HMI Touch color Baseline CH-HP-CR

Changes history

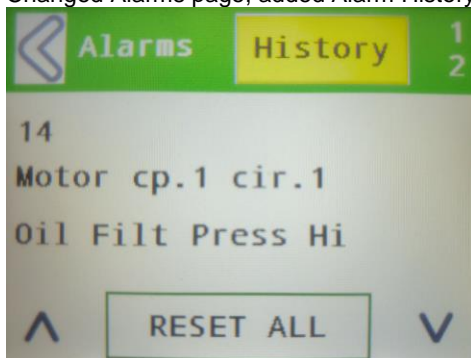
- Changed Alarms page, added Alarm History button and fixed 2nd line description.

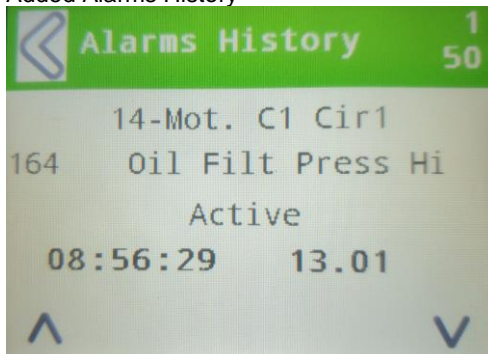
- Added Alarms History
